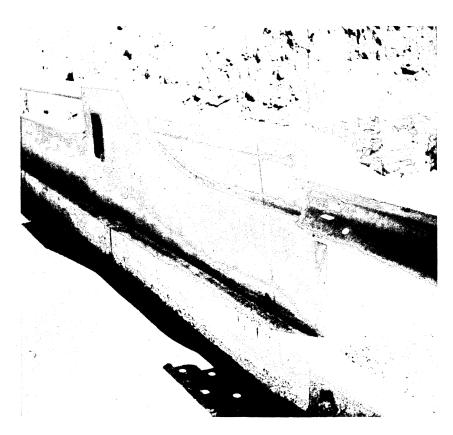
Here is the closeup of that same situation showing that this has not yet been resolved. The intent here, as I recall its being explained to us by State officials, was that there would be a post driven right alongside of the end of this abutment wall and through a right angle. The rail would be fastened at that point. The steel post would be fastened into the end of the abutment wall—end of the bridge wall, or the parapet wall here in this case.

Mr. Wilkes. I have a comment on the brush curb. As you can see, it is a practice in many of the New England States to provide a granite curb on many of the freeways and they carry it across the bridges. Although you can't tell from the photograph, I am sure that is a granite curb. It serves not only as a rub rail for vehicles but also protects your structures from the snowplows as they clear the roadways in the wintertime.

Mr. Constandy. That is granite, we have been told.
